# DESIGN REVIEW

for  
REMEDIAL ACTION  
at  
C.P.S./MADISON SITES

for  
New Jersey Department  
of Environmental Protection

by  
CH2M HILL

**Figure 5.3**  
**Preliminary Recommendation for the**  
**Locations of Three 160 GMP**  
**Decontamination Wells**

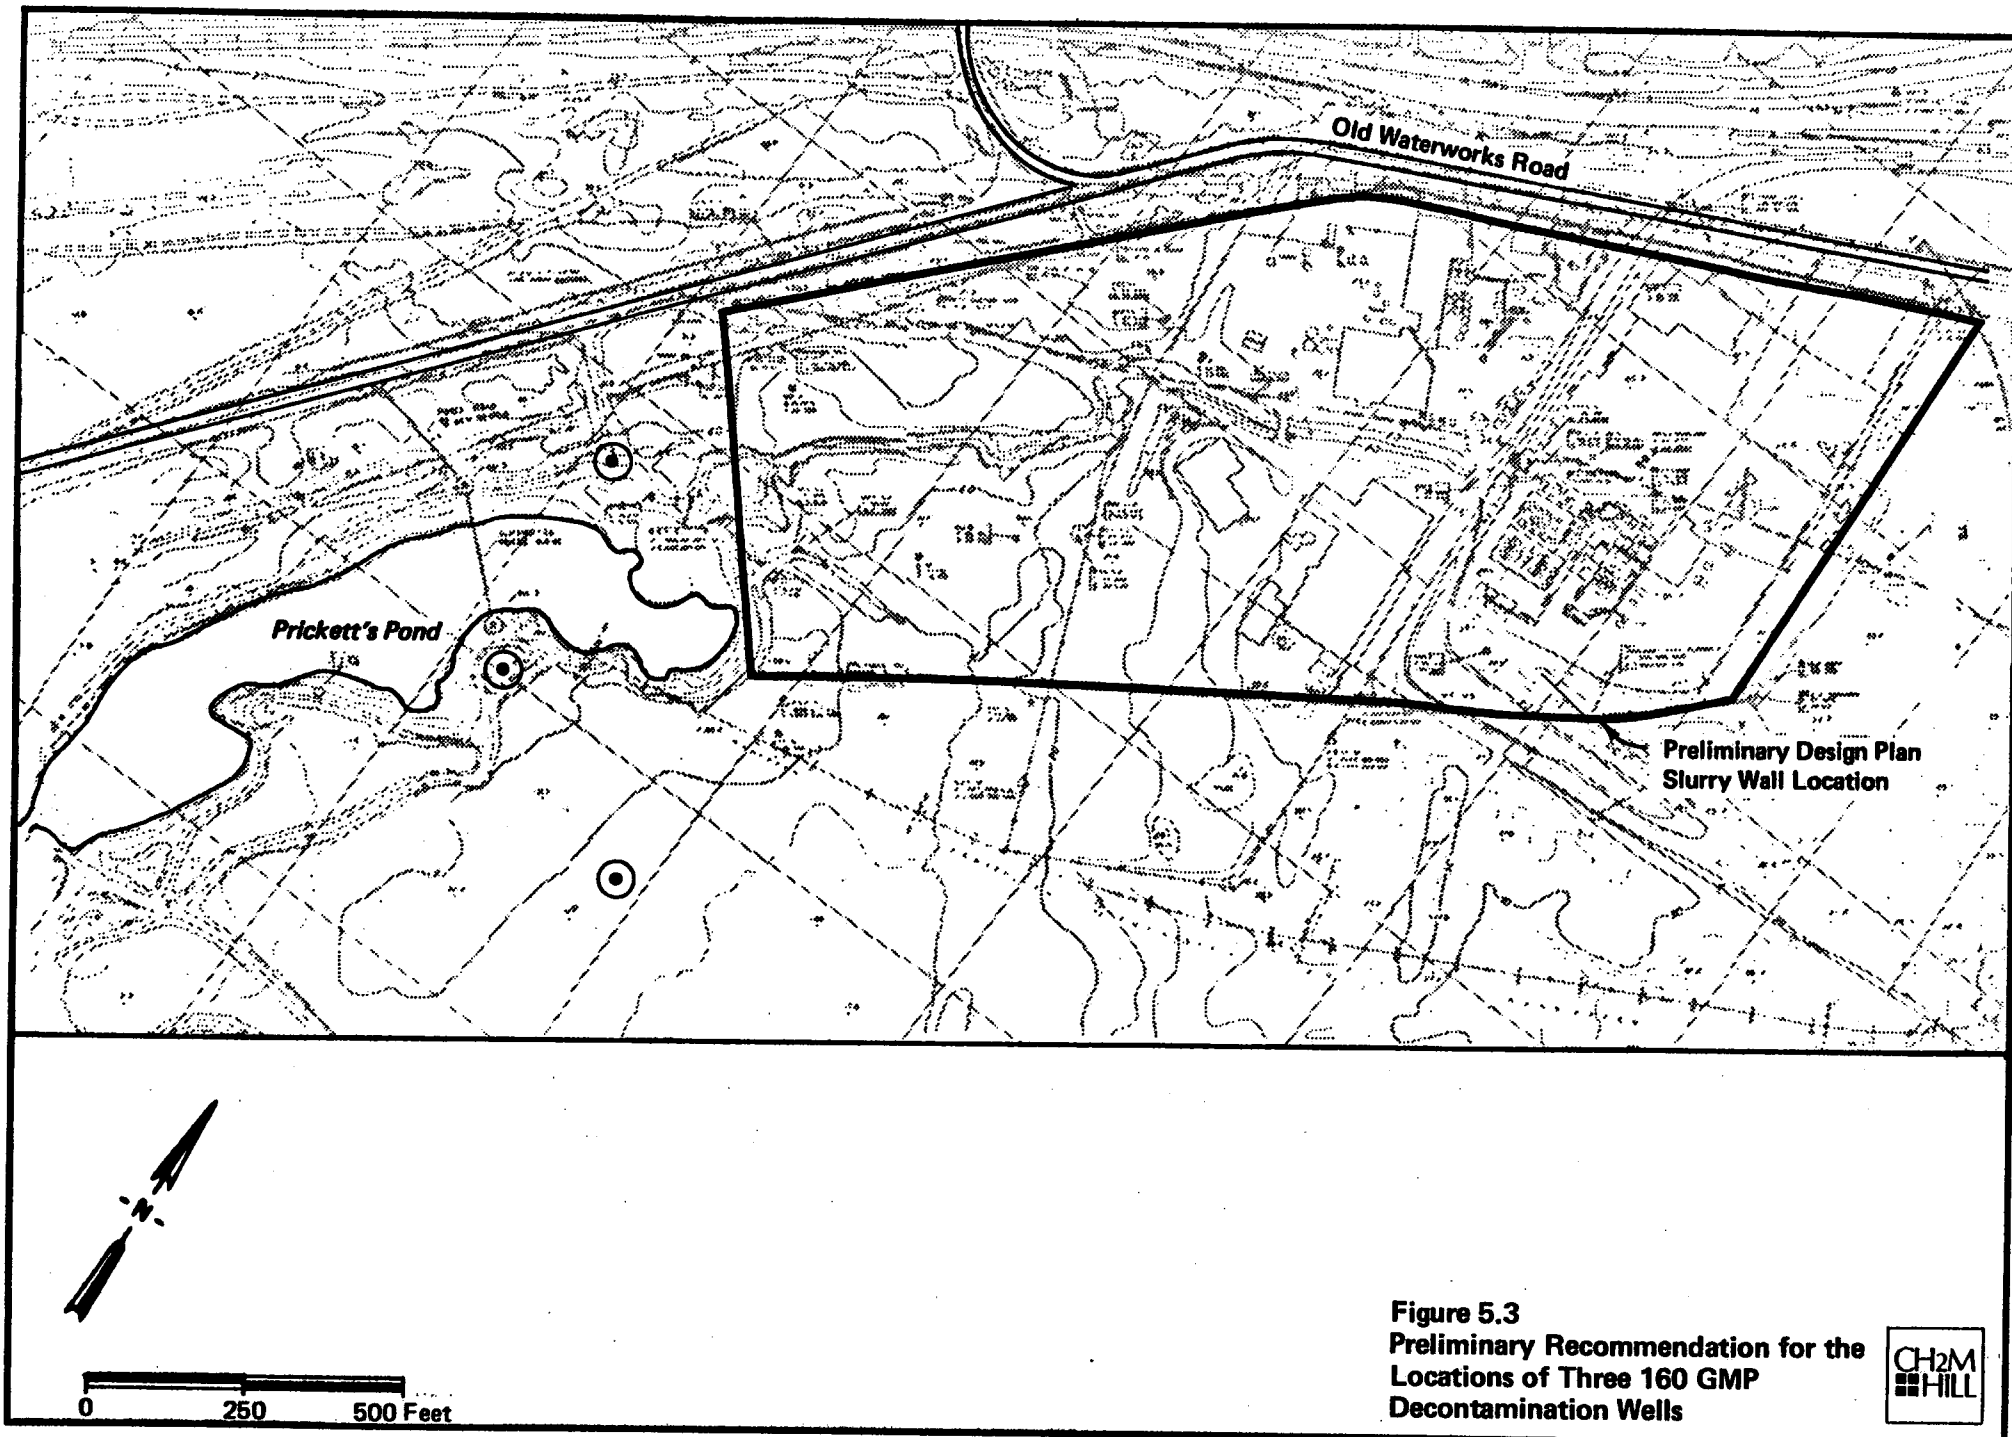
The Preliminary Design Plans show three decontamination wells outside of the proposed slurry wall. This configuration was evaluated to determine whether it would provide sufficient drawdown in the contaminated zone at realistic discharge rates. Historical data from water supply wells operated by the City of Perth Amboy indicate that 16-inch diameter wells in the aquifer are capable of sustaining steady state discharges between 500 and 700 gpm. It is assumed that significantly greater discharge rates (e.g., 2,100 to 5,000 gpm as proposed in the Dames and Moore

A potential configuration for three decontamination wells pumping at 160 gpm each is shown in Figure 5.3. Placement of a single decontamination well pumping at 300 gpm is shown in Figure 5.4. Given the average values of S and T calculated from the Wehran test, either system will provide one foot of drawdown along the assumed boundary of the contaminated zone within one week of the initiation of pumping. The three well system will provide greater assurance that contaminants will not migrate downgradient of the groundwater recovery zone.

The preliminary design recommendation for a decontamination well system consists of three wells discharging at 160 gpm each. Proposed locations for these wells are shown in Figure 5.3.
